ADDENDUM NUMBER TWO (2)

Project: Health Sciences Complex (Rankin Campus)
Hinds Community College
Pearl, MS
HCC Bid #3298
PN: 21041

FROM: Dean Architecture, P.A.
661 Sunnybrook Road, Suite 140
Ridgeland, MS 39157
(601) 939-7717

PC-5
 REINF. W/ 9 #8 TOP AND BOT., E.W.
 DEPTH = 3'-0"
 NOTE: PROVIDE 180 STANDARD HOOK EA. END OF REINF.

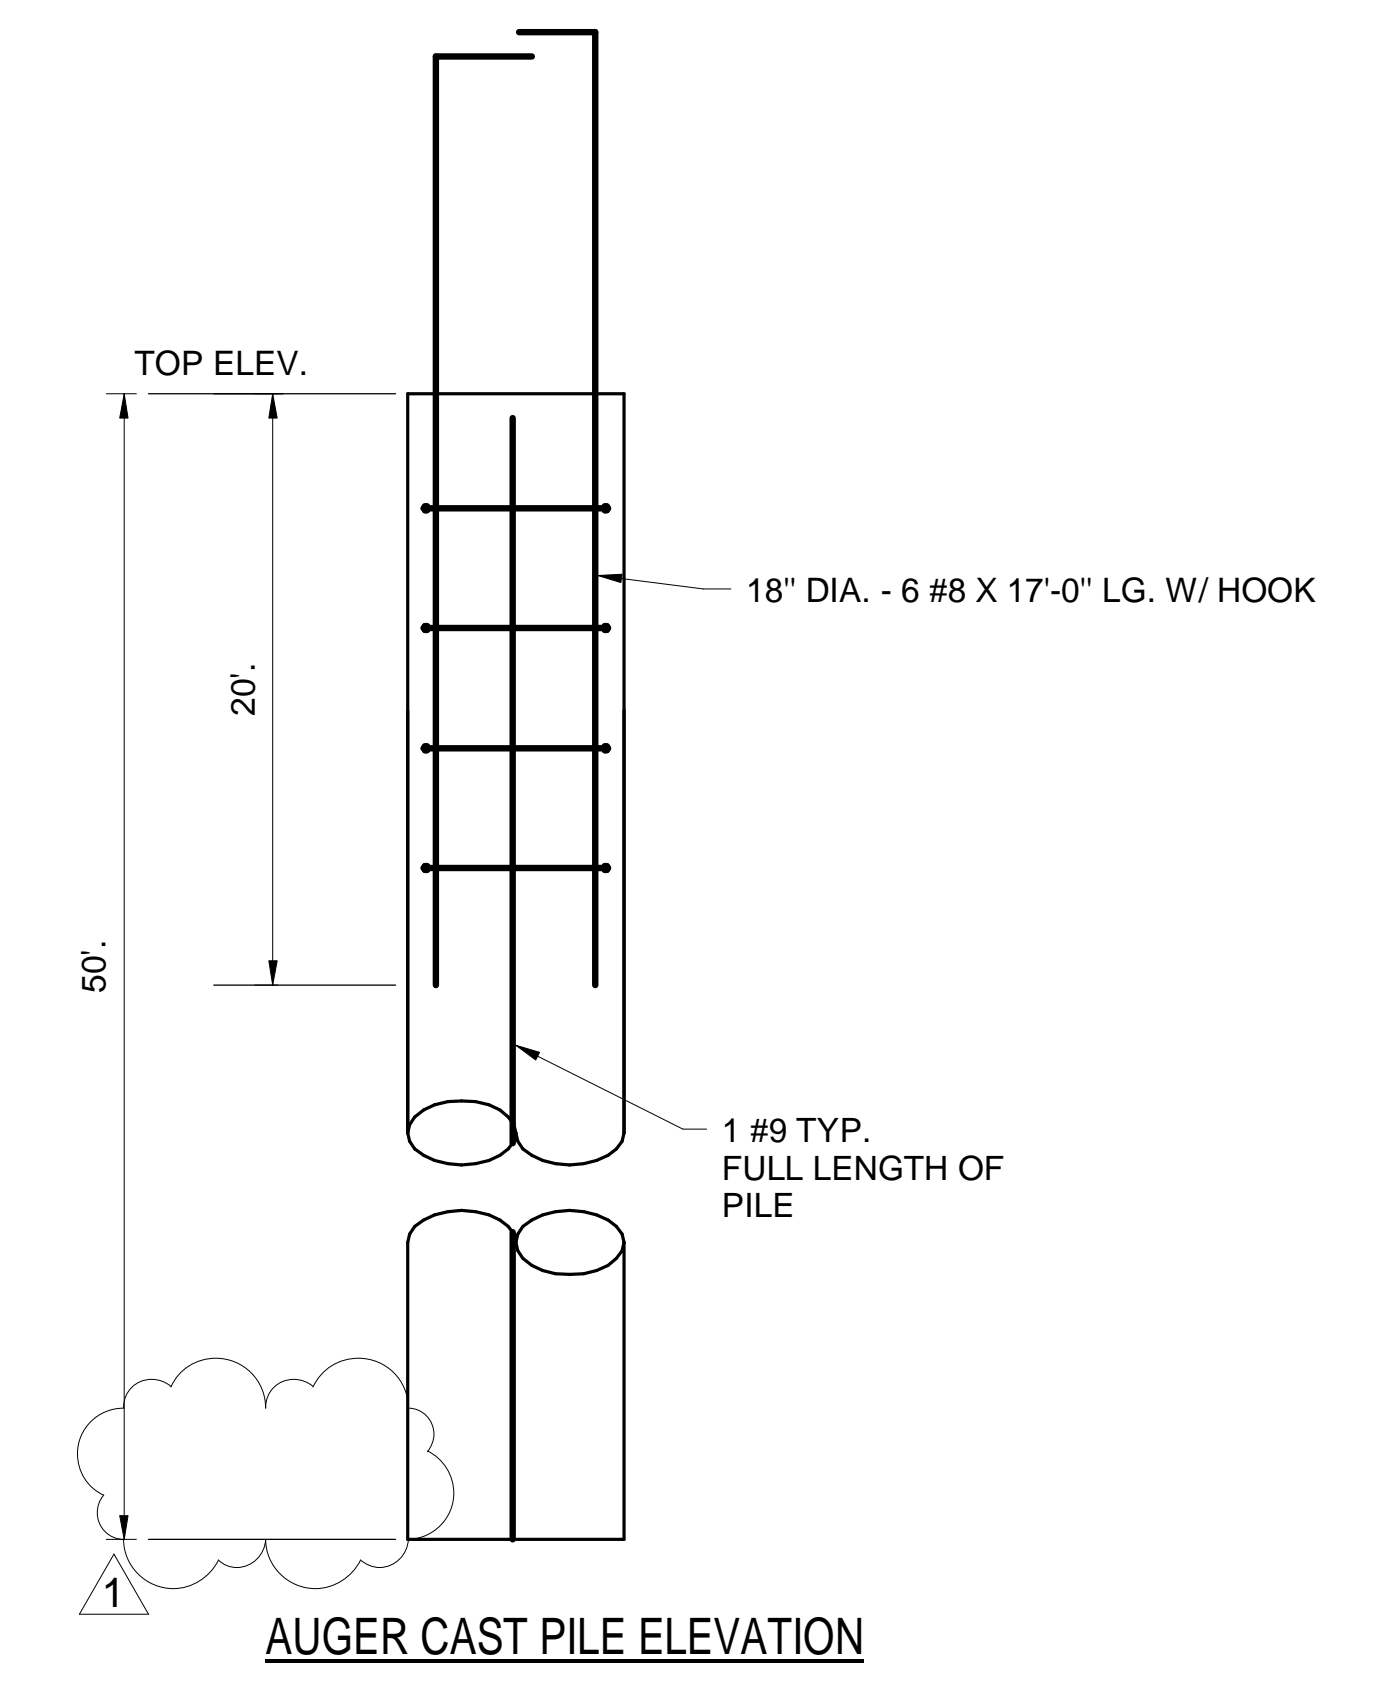
Item No. 1 Ref. Sheet S203 – Replace sheet S203 with attached sheet S203. (Revised PC-1)

Sheet Number:
M106
GROUND FLOOR HVAC PLAN - PART "B"

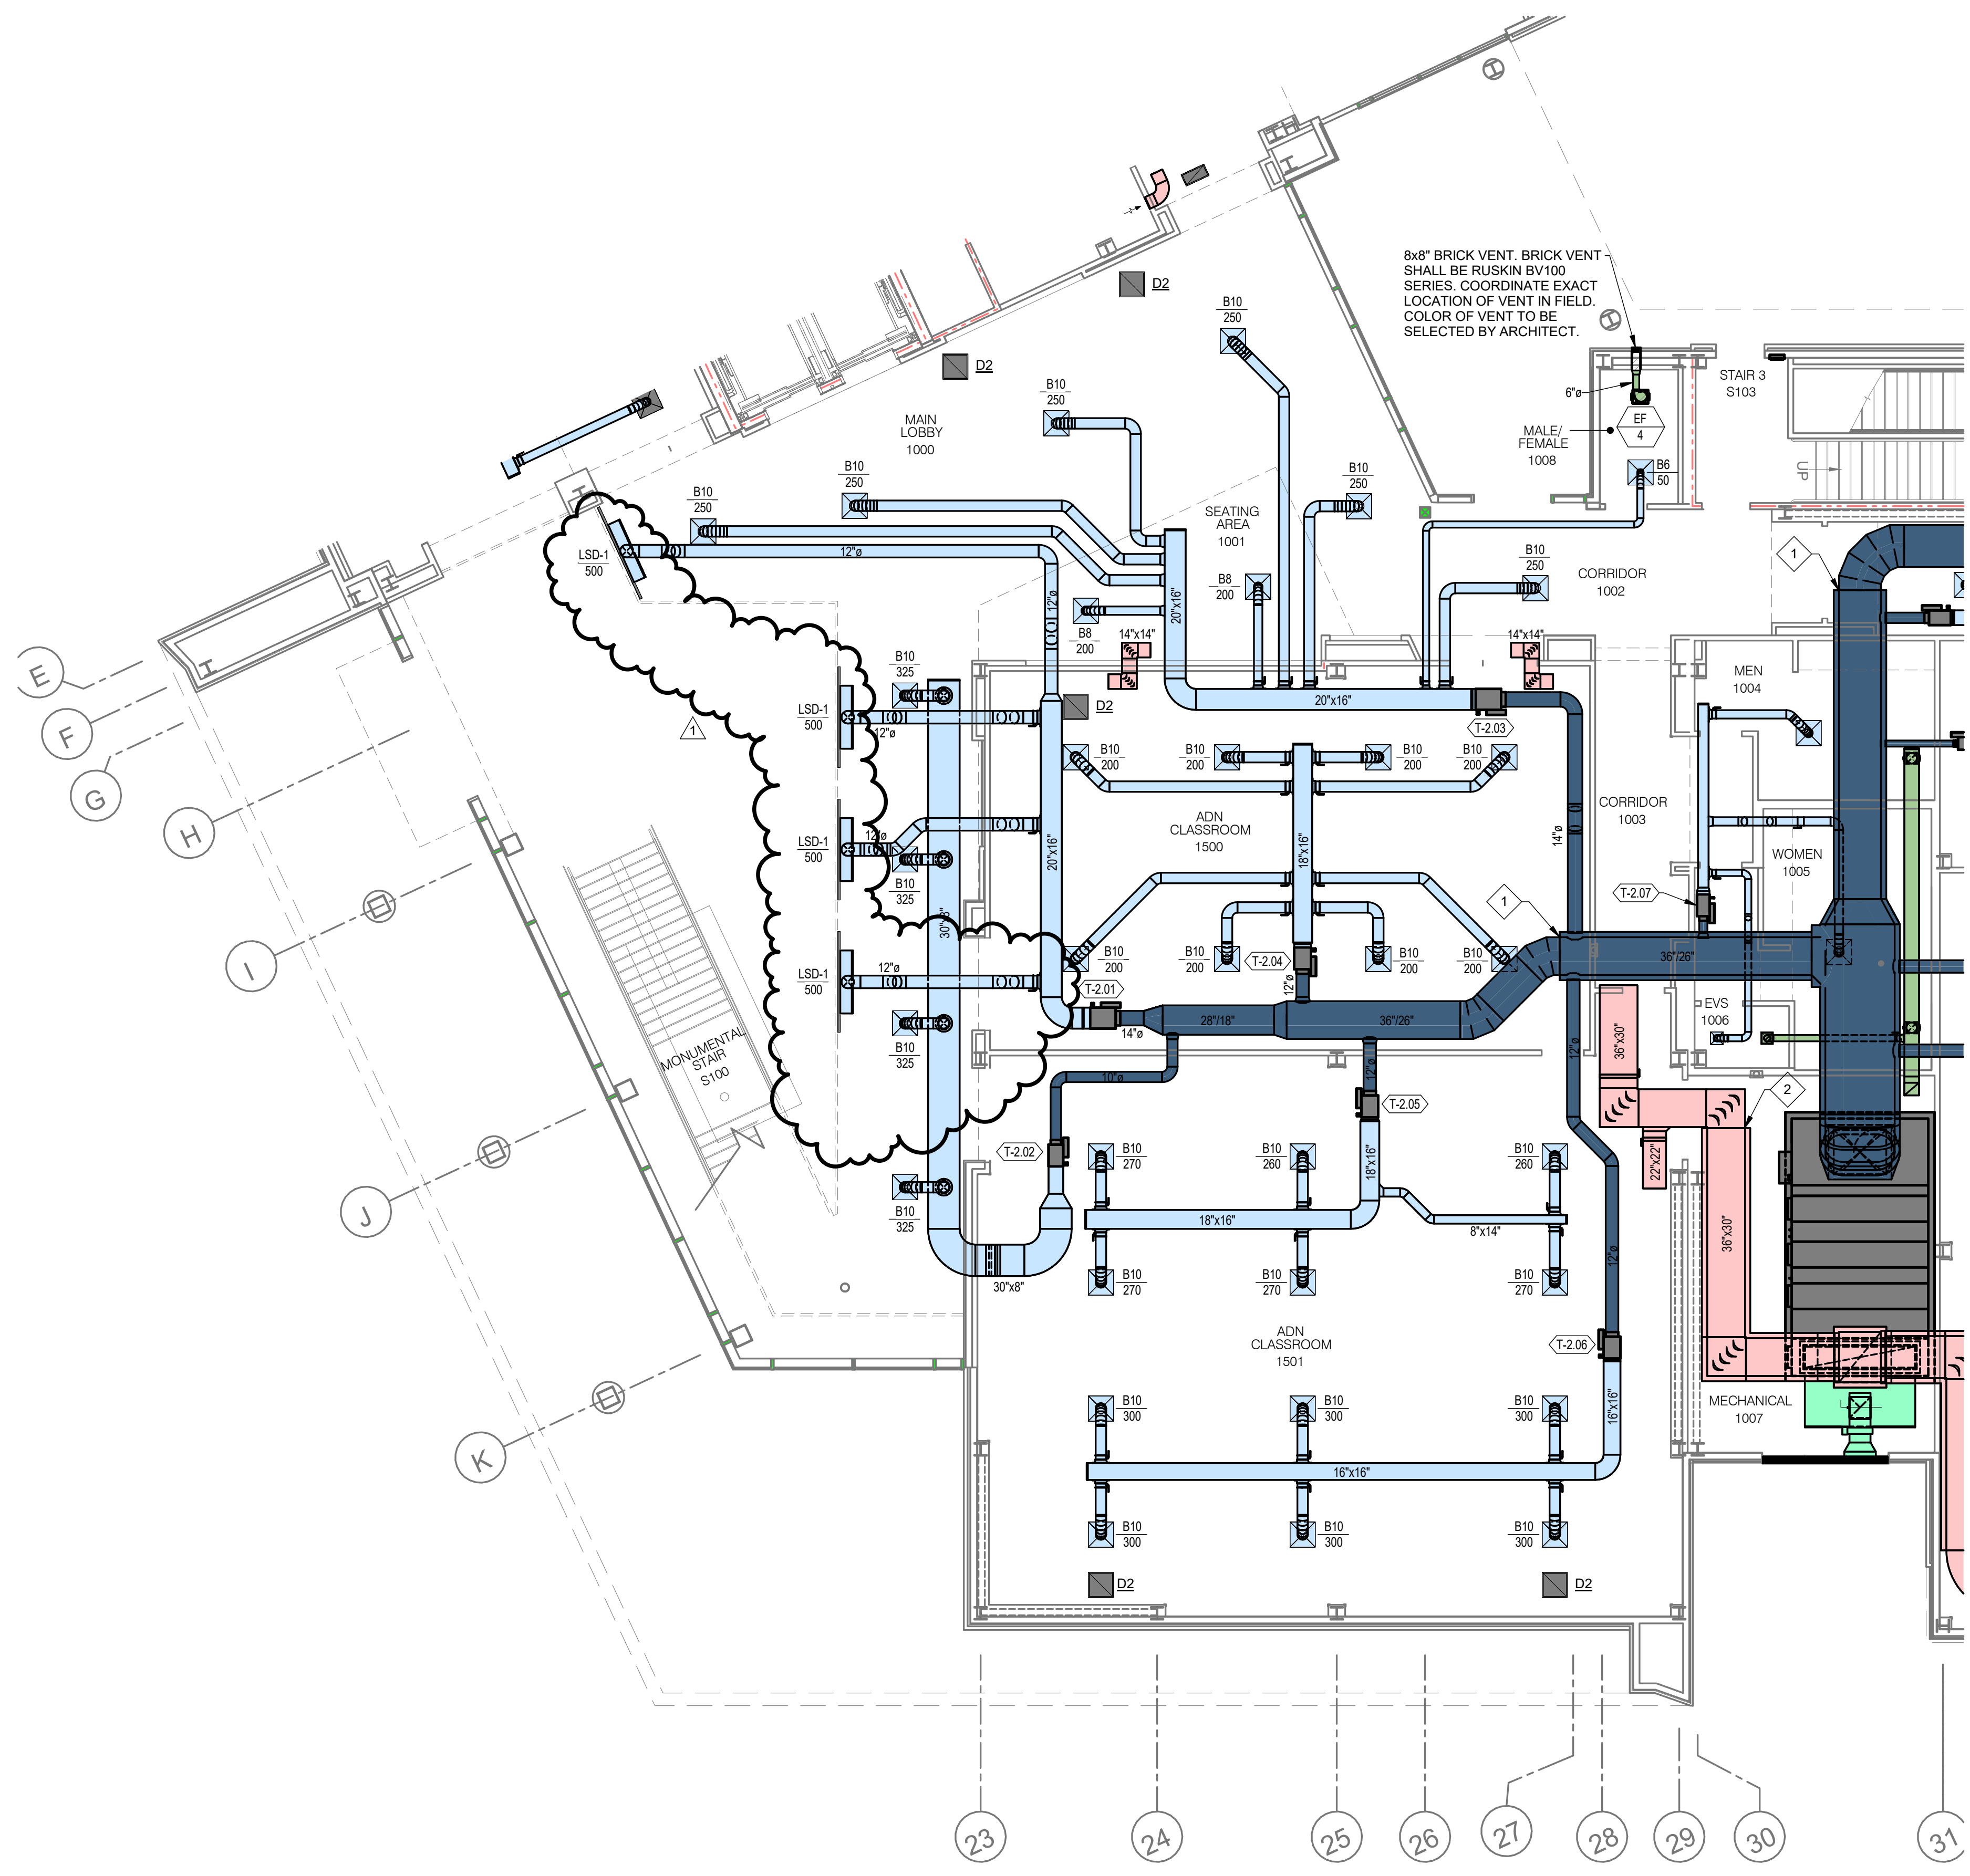
B. M106

- a. Replace this sheet in its entirety.
- b. Removed LSD-1 at stair and adjust airflow to remaining LSD-1 slots.
- c. Revised Note 1 and Note 2.

1 ENLARGED MECHANICAL YARD HVAC FLOOR PLAN
M401 1/4" = 1'-0"

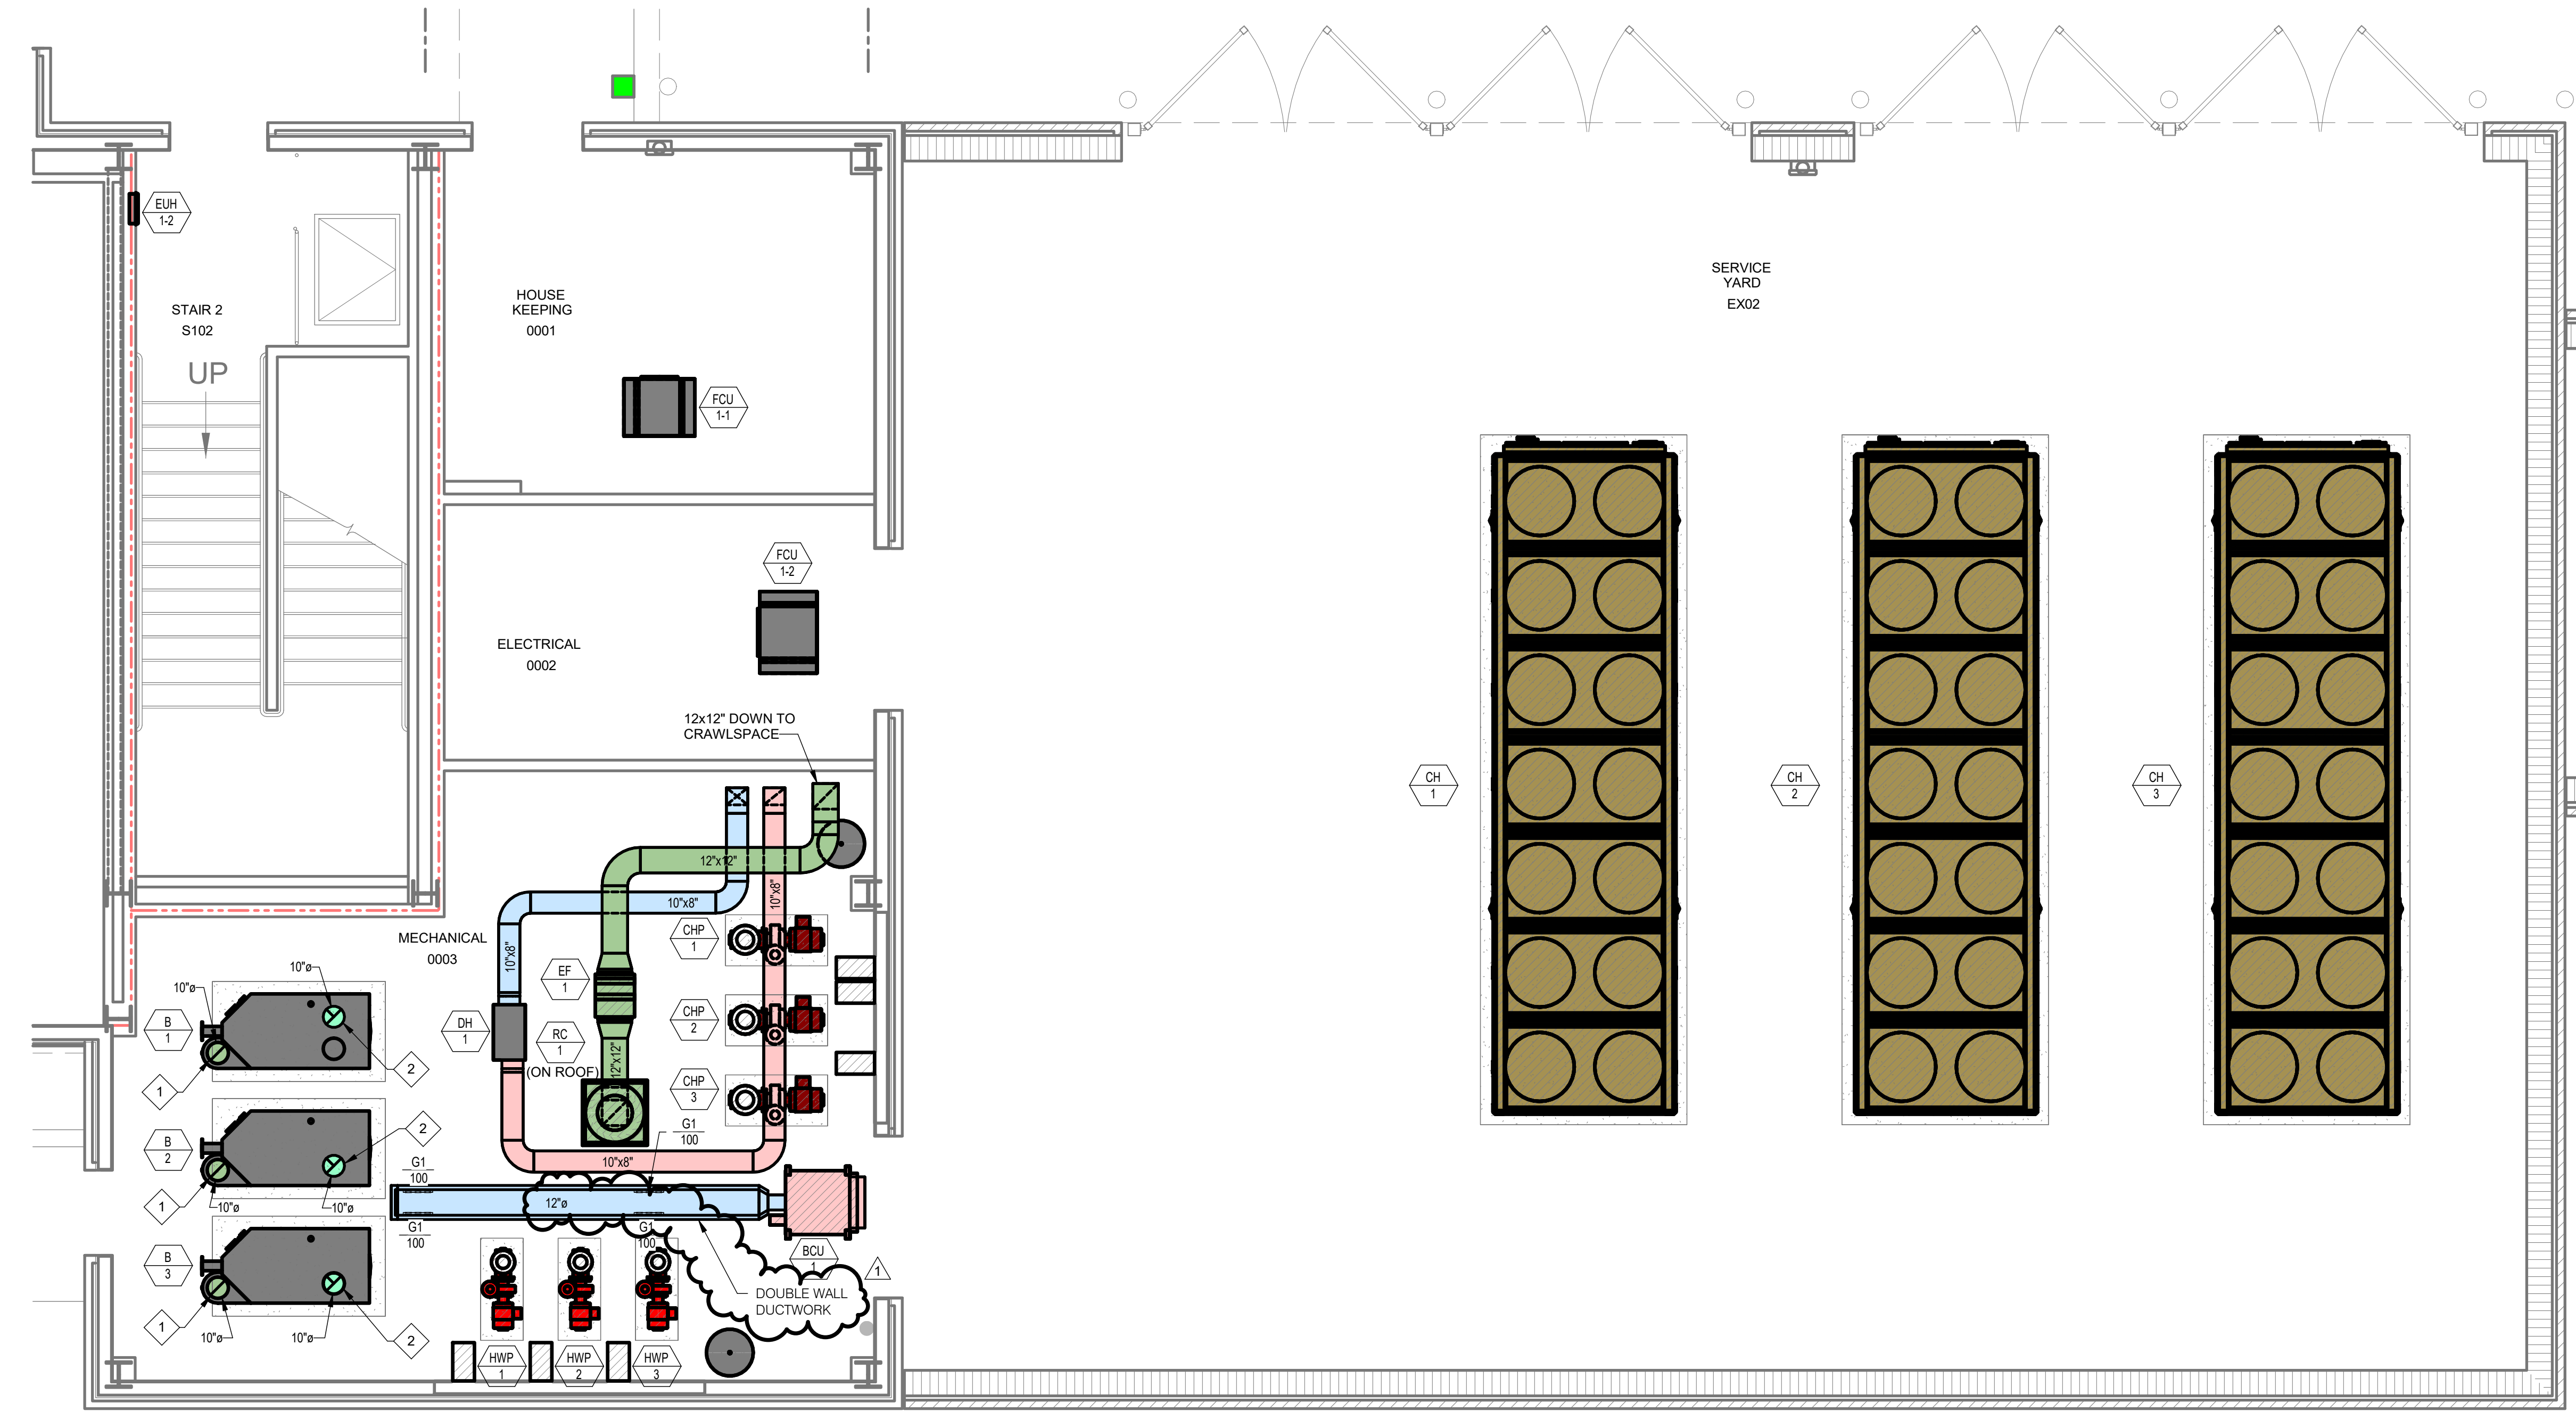
D. M401

- a. Replace this sheet in its entirety.
- b. Duct from BCU-1 is 12" round and shall be double wall with flanges.
